EPA Comments on December 22, 2006, Evaluation of the Surficial Aquifer Containment System for the Koppers Superfund Site (Gainesville, Florida), prepared by GeoTrans for Beazer East:

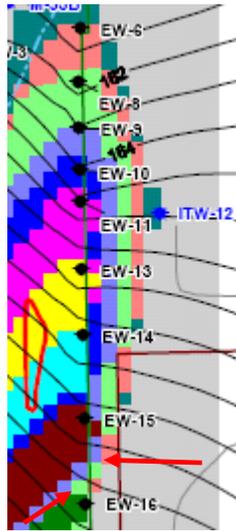
4. It is difficult to determine from the figures provided how particles released at certain locations manage to reach a distant extraction well location. For example, referring to Figure 2 (a portion is reproduced below) it is hard to see how particles released just north and northwest of EW-16 (light green color, noted by red arrows below) eventually migrate to EW-8.

In this example, pathlines from the release points in the upper surficial aquifer near EW-16 must proceed under the model layer where the particles are released in order to avoid crossing other pathlines at upper aquifer release points further north. This three-dimensional aspect of particle transport is not shown on Figure 2. There is probably a limited ability to show particle movement in three dimensions, particularly because of the large number of particles released. The text, therefore, needs to include language that explains how particles released in the upper part of the aquifer may move downward into underlying model layers before reaching the discharge point.
